SUBJECT: Savannah River Site's Responses to the Regulatory Comments on the 5-Year Monitoring Report (Data Summary Letter) for the K-Area Groundwater Operable Unit, 2016 through 2020 (IACD-20-182, dated September 29, 2020), SEMS Number: 99

SRS Responses to the U. S. Environmental Protection Agency's Comments on the 5-Year Monitoring Report (Data Summary Letter) for the K-Area Groundwater Operable Unit, 2016 through 2020 (IACD-20-182, Dated September 29, 2020), SEMS Number: 99

SRS Responses to U.S. Environmental Protection Agency Comments on the 5-Year Monitoring Report (Data Summary Letter) for the K-Area Groundwater Operable Unit, 2016 through 2020, SEMS Number: 99, (IACD-20-182, Dated September 29, 2020), Savannah River Site, Aiken, South Carolina

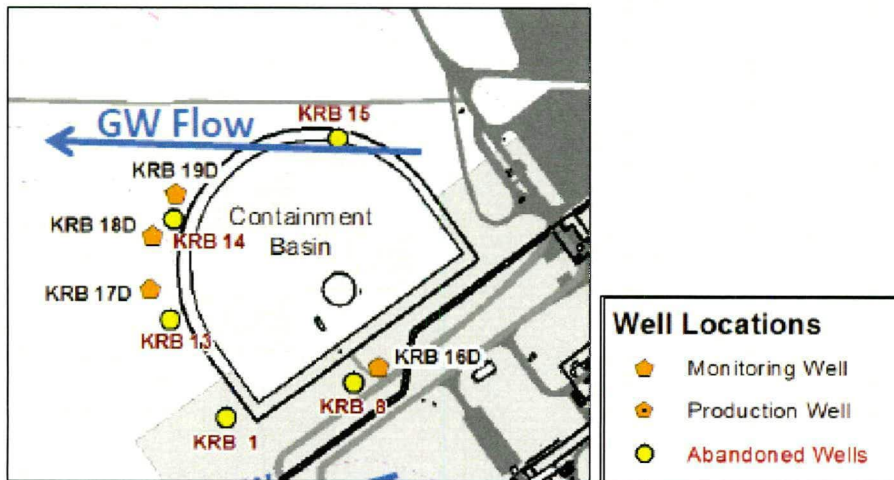
3. Based on the tritium results in well KRB 19D, it appears the vertical extent of contamination is not defined in groundwater directly downgradient of the K-Area Containment Basin (904-88G). For example, under the subheading KAGW OU Tritium Results, Monitoring Well Results, page 4, the text states tritium trends are steadily decreasing in KRB 19D where the highest concentrations of tritium are detected in KAGW OU at a concentration of 2,090 picocuries per milliliter (pCi/mL) in 2020 which is above the maximum contaminant level (MCL) of 20 pCi/mL. Additionally, according to the sample event water elevation data presented in Attachment 1. KAGW 5-Year Data Table 2016 through 2020, well KRB 19D appears to be the deepest well of the six KAGW OU upper water bearing zone (UWBZ) wells currently being monitored. Thus, it appears the vertical extent of tritium groundwater contamination is currently not defined at KRB 19D with concentrations of tritium at a magnitude of 10X above the MCL for tritium within the well furthest downgradient of potential tritium sources and within the deepest water column of the wells within the monitoring well network. While it is currently understood the six KAGW OU monitoring wells only represents annual sampling of a subset of wells currently available, it is not known whether additional wells

are available to be sampled to address the data gap in the vertical extent of tritium contamination. *Please revise the Letter Report to discuss addressing the data gap in the vertical extent of tritium contamination as pre-work plan characterization data in advance of the remedial investigation.*

Response: Clarification

There are no deeper wells in the vicinity of or downgradient of the K-Area Containment Basin (904-88G). Two monitoring wells, KRB 18D and KRB 17D (see image below), are located to the southwest but are screened similarly to KRB 19D with screen zones of 75-95 ft bgs. As discussed and agreed to during the 2015 Core Team meeting, the intent of the KAGW annual monitoring is to provide pre-work plan characterization data and long-term trends since the characterization field start is not until 2042. The current monitoring is looking for near source release data and changes over time until the KAGW characterization begins. These data will be used for planning further characterization efforts during the actual Workplan Characterization. No changes are proposed to the monitoring network or 2020 5-Year Monitoring Report.

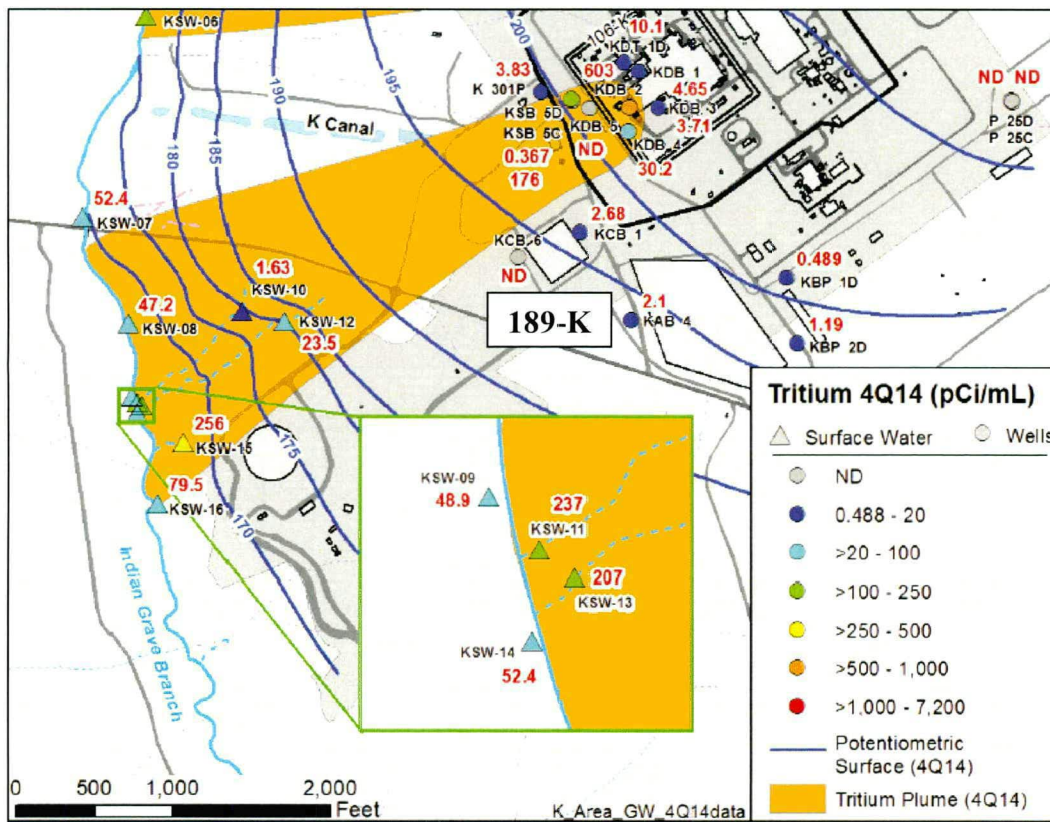
- Based on the tritium results at surface water sampling station KSW-16, the extent of surface water contamination downstream of the K-Area Reactor Complex tritium plume is not clearly defined. For example, the 2020 tritium concentration in KSW-16 was measured at 51.4 pCi/mL and exceeding than MCL of 20 pCi/mL. It is noted the bounding downstream tritium surface water sample location is KSW-17 which measured tritium at 8.29 pCi/mL. However, KSW-17 is located past the confluence of Indian Grave Branch and Pen Branch and located outside of the KAGW OU. As such, there appears to be a data gap in the downstream extent of tritium contamination within the KAGW OU and in Indian Grave Branch prior to its confluence with Pen Branch. *Please revise the Letter Report to discuss addressing the data gap in the downgradient extent of tritium*

contamination in Indian Grave Branch within the KAGW OU and prior to the confluence as pre-work plan characterization data in advance of the remedial investigation.

Response: Agree/Clarification

K-Area is the only tritium source to the Indian Grave/Pen Branch stream system, so the influence of Pen Branch prior to its confluence with Indian Grave Branch is not a concern with respect to the tritium source. There are currently no surface water stations between KSW-16 and KSW-17. Practical access to Indian Grave Branch south of KSW-16 is exceptionally difficult since there is no permanent road access and the area is heavily wooded/undeveloped until reaching KSW-17 along highway SC 125, with wetland features increasing further downstream. Based on the significantly higher flow measured at KSW-17 as compared to KSW-06, it is conservatively expected that tritium concentrations in Indian Grave Branch will remain above the MCL until the confluence with Pen Branch. Additionally, the 2014 sampling with additional wells in K-Area showed there was not an impact further to the south at the old 189-K Coal Storage Run-off Containment Basin and also that the tributaries within the plume footprint were providing the most contamination to Indian Grave Branch (see image below). No changes to the 2020 5-Year Monitoring Report or monitoring network are proposed.
